PLANNING COMMISSION MEETING STAFF REPORT

DATE OF MEETING: December 10, 2019
NAME OF PROJECT: Watts Remund Farms
NAME OF APPLICANT: Watts Enterprises
AGENDA ITEM: Preliminary Phases 2, 3A, 3B and 3C
LOCATION OF ITEM: 600 North 200 East
ZONING DESIGNATION: R-1-15

Subject: Remund Farms, Phase 2, 3A, 3B, & 3C Preliminary Approval

WATTS ENTERPRISES
 REMUND FARMS
 PRELIMINARY SEWER PLAN
 PHASE 2 & 3

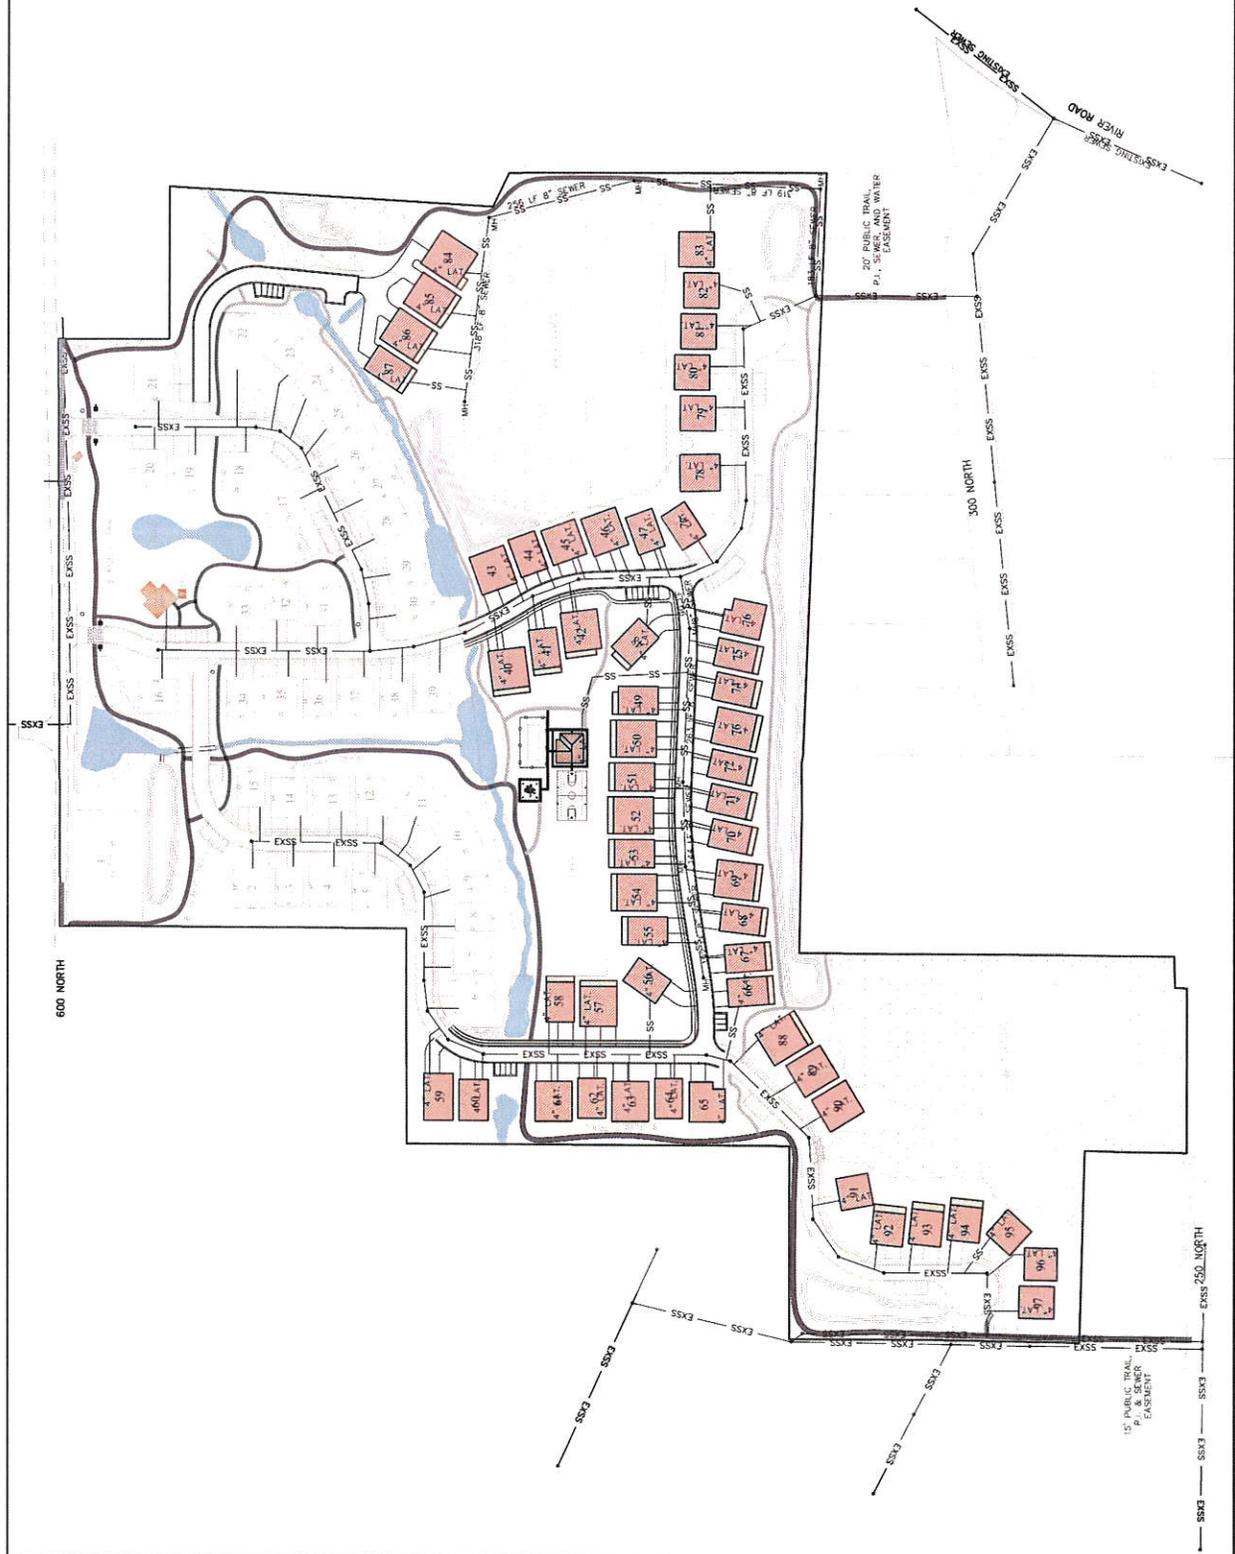
- Part of Phase 2 shows a back-lot sewer line. The new sewer line should not encroach into the delineated wetlands area. This line will service lots 84 -87.
- To provide access to the sewer line, it should be placed in the cross section of the trail. All manholes shall be located within the trail shoulder or pavement. The cross-section of the trail shall be built to the roadway cross-section.

WATTS ENTERPRISES
 REMUND FARMS
 PRELIMINARY PRESSURIZED
 IRRIGATION PLAN - PHASE 2 & 3

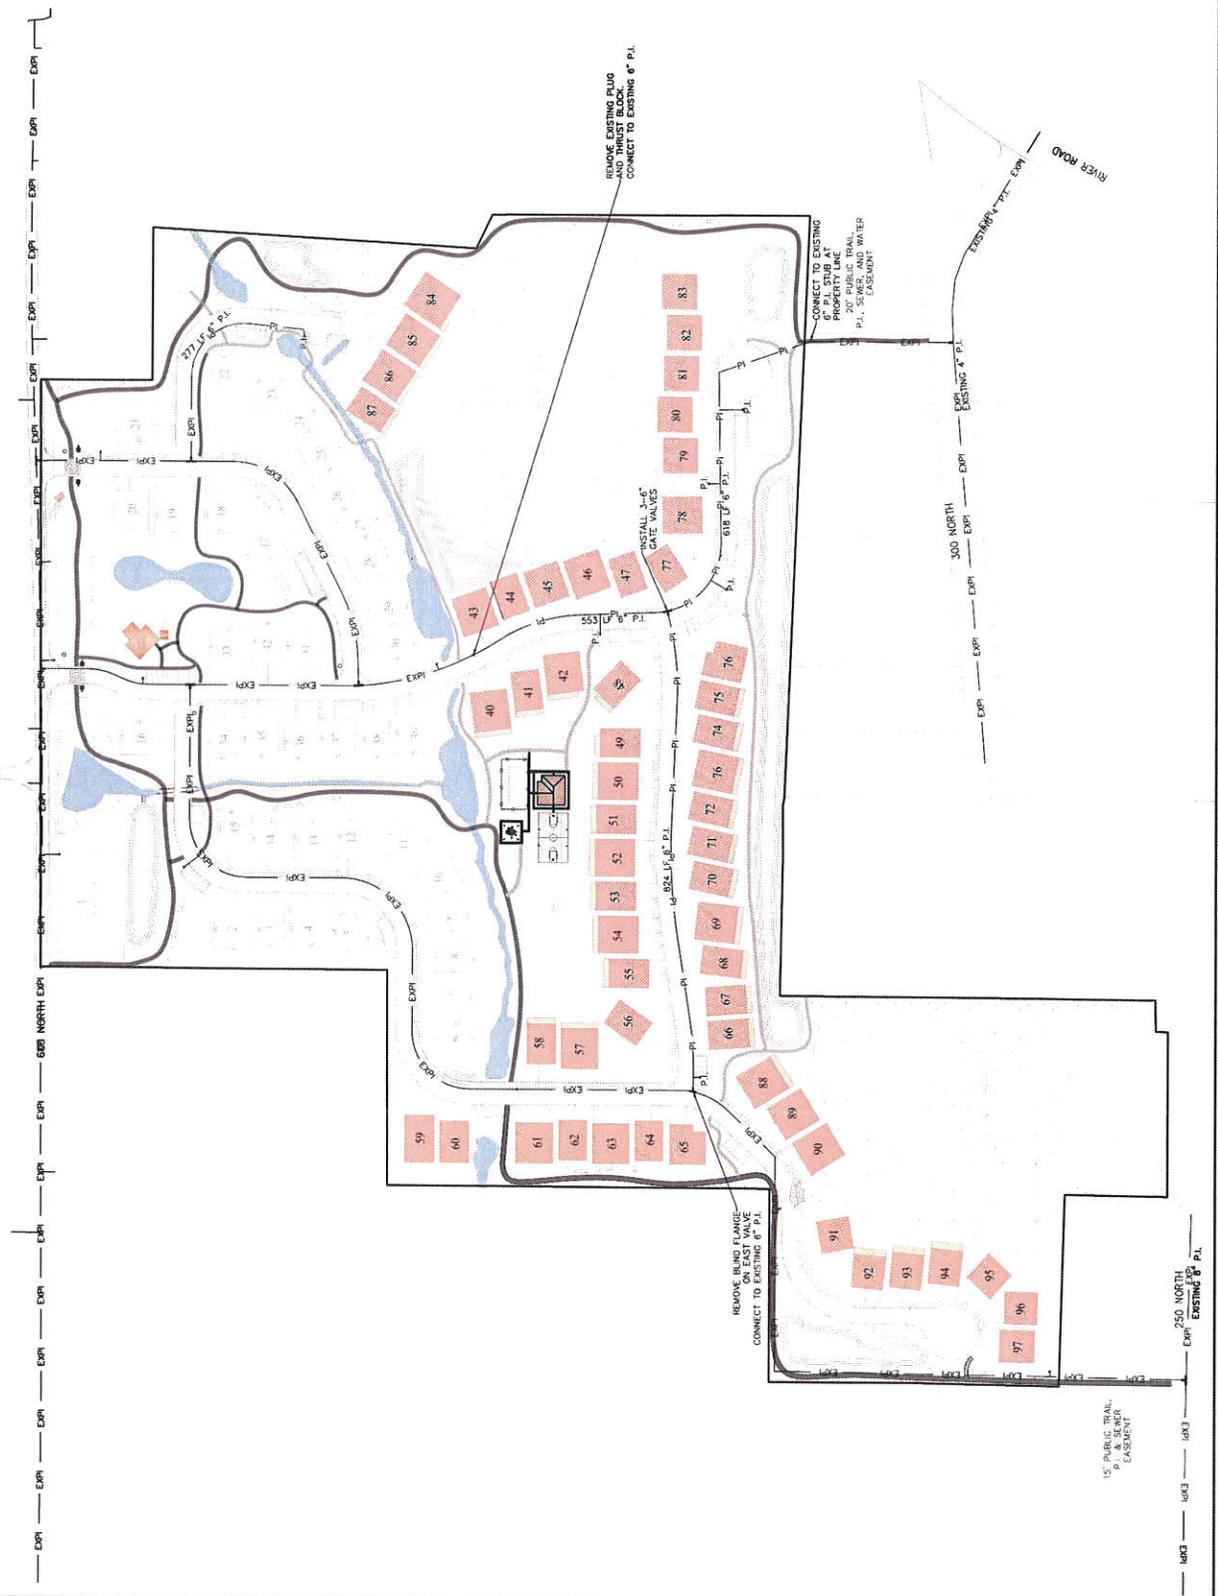
- The proposed development will connect to existing irrigation from Phase 1 and install services with meters according to Midway Irrigation Company standards.
